**DEFENSE NUCLEAR FACILITIES
SAFETY BOARD**

November 1, 2013

Staff Issue Report

SUBJECT: Safety and Integrity Implications of Decanting Liquid from Hanford Tank 241-AY-102

Figure 5. Tank AY-102 refractory temperatures from a thermocouple 21 ft from the tank centerline when the primary ventilation system is on and the annulus ventilation is cycled on and off (source: Tank Waste Information Network System).

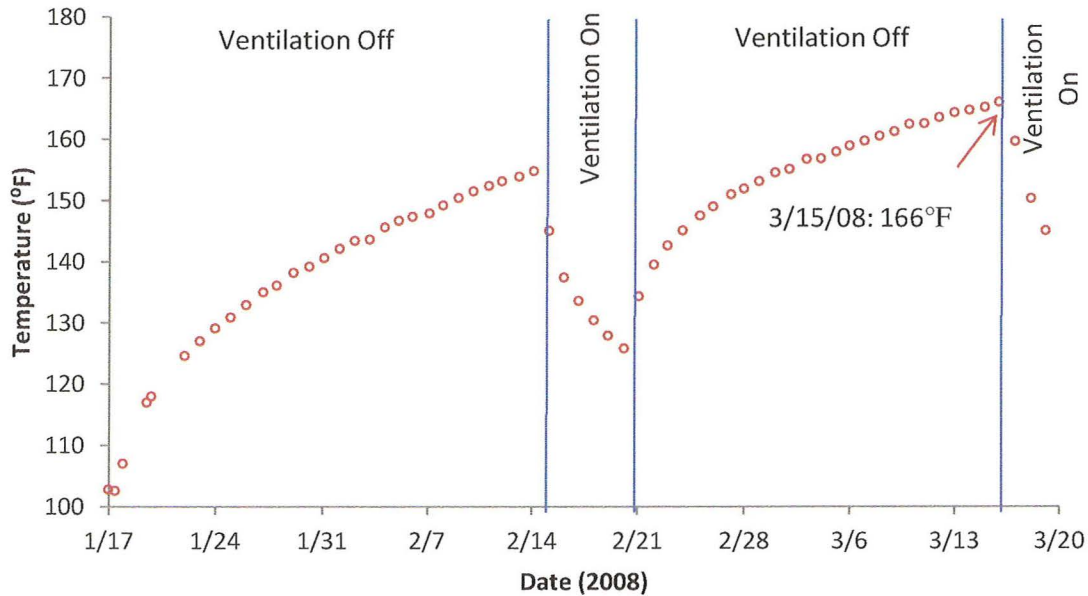
ventilation system. The staff members' analysis finds that temperatures on the tank bottom increase significantly when the annulus ventilation system is off. Figure 5 shows that the temperature of the refractory layer at the tank bottom increased steadily during a test when the primary ventilation system was on and the annulus ventilation system was cycled off. When the ventilation system was cycled on, the tank bottom was rapidly cooled.

After a decade of additional radioactive decay after retrieval from tank C-106 in the 1990s, on March 15, 2008, the temperature of the tank AY-102 refractory reached about 166°F and appeared to be steadily increasing until the annulus ventilation system was turned back on at the end of the test (see Figure 5). Based on these data, it is apparent that the historical C-106 maximum solids temperature range of 160 to 170°F does not represent an upper bound for tank AY-102. Because the half-life of the radioisotopes primarily responsible for the decay heat in the tank waste is about 30 years, 5 years for additional radioactive decay from 2008 to 2013 is not expected to significantly change this conclusion. These data show that a prolonged annulus ventilation outage will raise the temperature of the tank bottom, which may lead to increased hydrogen generation and corrosion rates. Higher localized tank temperatures can exist between tank thermocouple locations. The final tank temperatures cannot be accurately predicted or bounded with the existing WRPS analysis. A multi-dimensional, transient thermal transport model would be useful in assessing tank bottom temperature increases relative to corrosion control limits resulting from restricted air flow on the tank bottom.
